DISCUSSION OF CHANGES
ITS: 3.3.8.1 - LOSS OF POWER INSTRUMENTATION

DISCUSSION OF CHANGES
ITS: 3.3.8.1 - LOSS OF POWER INSTRUMENTATION

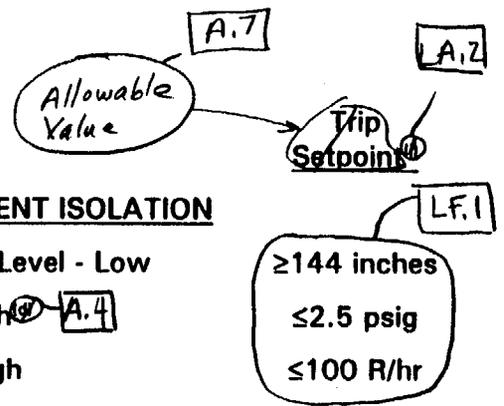
1. 3. MAIN STEAM LINE (MSL) ISOLATION					
1.a	a. Reactor Vessel Water Level - Low Low	≥84 inches	2	1, 2, 3	D 21
b.	MSL Tunnel Radiation - High ^(b)	≤15 ^(m) x normal background	2	1, 2, 3	21

1.b, 1.c	c. MSL Pressure - Low	≥825 psig	2	1	E 22
1.d	d. MSL Flow - High ⁽ⁿ⁾	≤140% of rated	2/line	1, 2, 3	D 21
1.e	e. MSL Tunnel Temperature - High	≤200°F	2 of 4 in each of 2 sets	1, 2, 3	D 21

A.5 moved to ITS 3.3.6.2 3.3.7.1

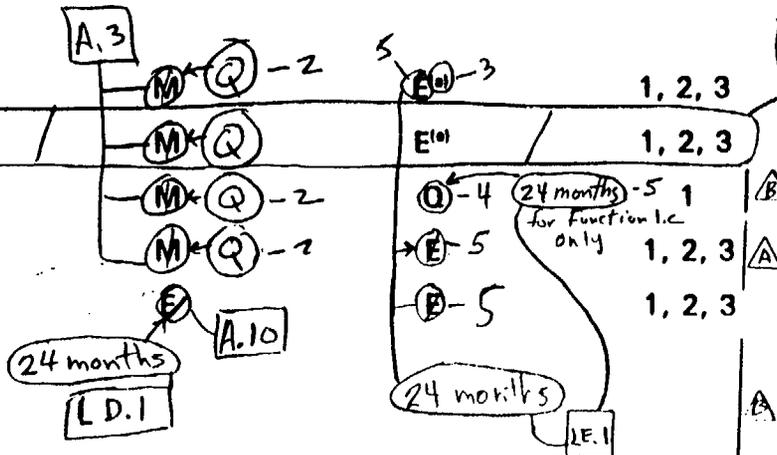
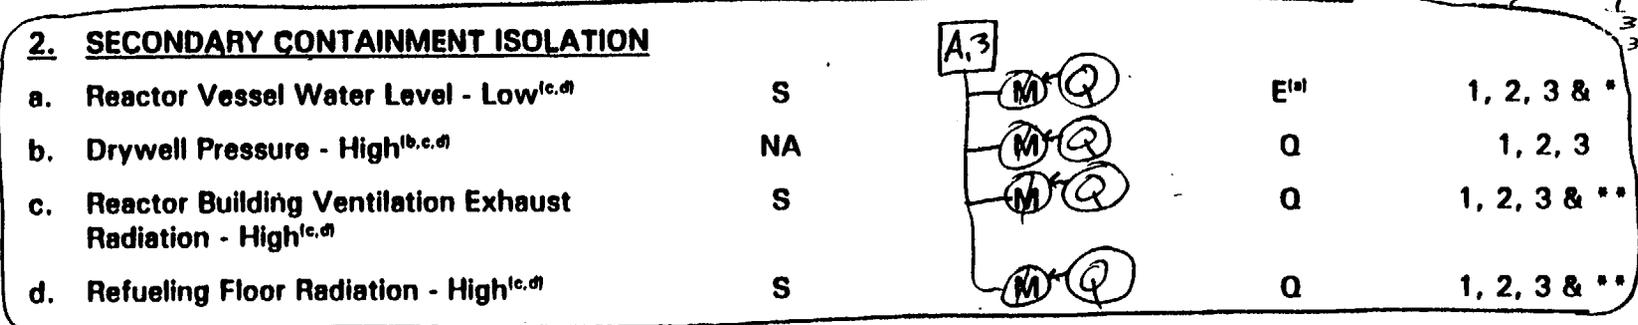
3. MAIN STEAM LINE (MSL) ISOLATION				
1.a a. Reactor Vessel Water Level - Low Low	S-1	M-Q -2	E-3	1, 2, 3
b. MSL Tunnel Radiation - High	S	M-Q	E ^(A)	1, 2, 3

1.b, 1.c c. MSL Pressure - Low	NA	M-Q -2	Q-4	1
1.d d. MSL Flow - High ^(A.5)	S-1	M-Q -2	E-5	1, 2, 3
1.e e. MSL Tunnel Temperature - High	NA	E	B-5	1, 2, 3

A.5 moved to I.T.S. 3.3.6.2 3.3.7.1

ACTION A

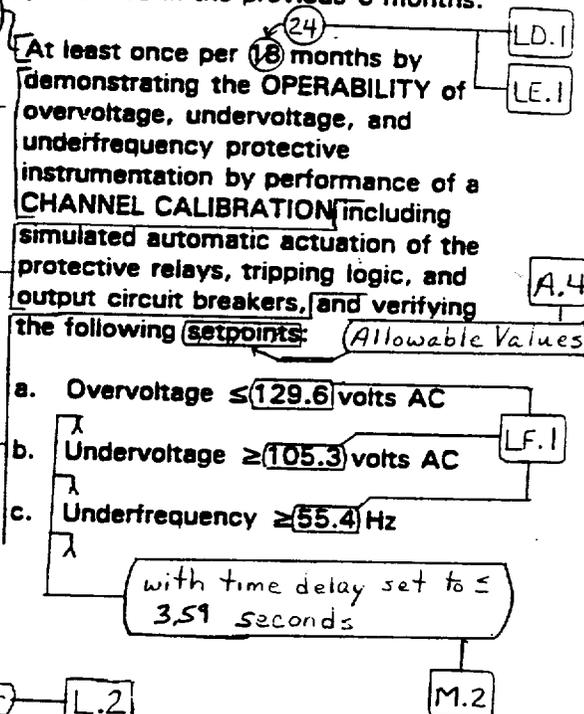
2. With both RPS electric power monitoring CHANNEL(s) for an inservice RPS MG set or alternate power supply inoperable, restore at least one electric power monitoring CHANNEL to OPERABLE status within 30 minutes or remove the associated RPS MG set or alternate power supply from service.

Add proposed ACTION C
Add proposed ACTION D

Table 3.3.5.1-1 (page 3 of 6)
Emergency Core Cooling System Instrumentation

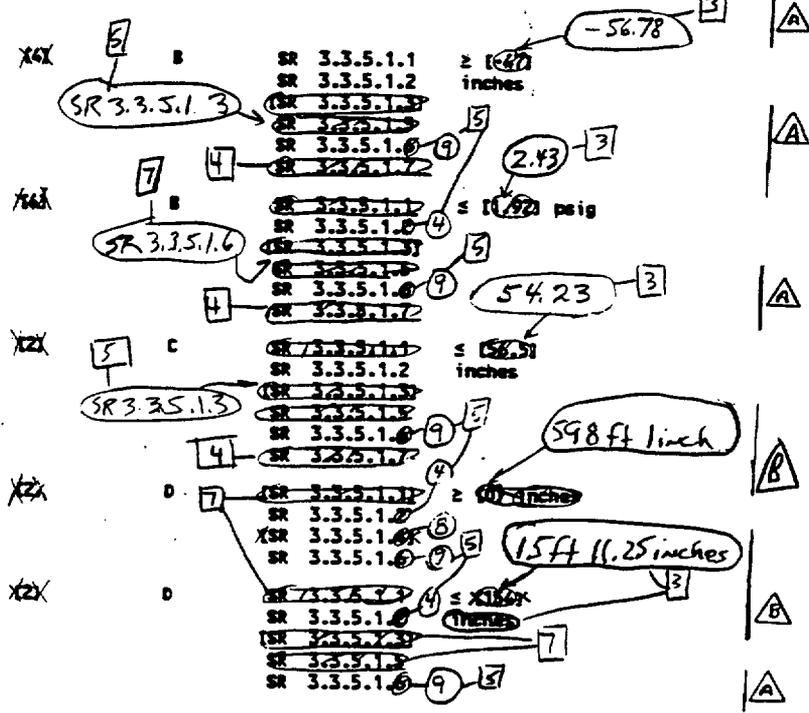
Insert Functions 2.g, 2.h, 2.i, 2.j, and 2.k
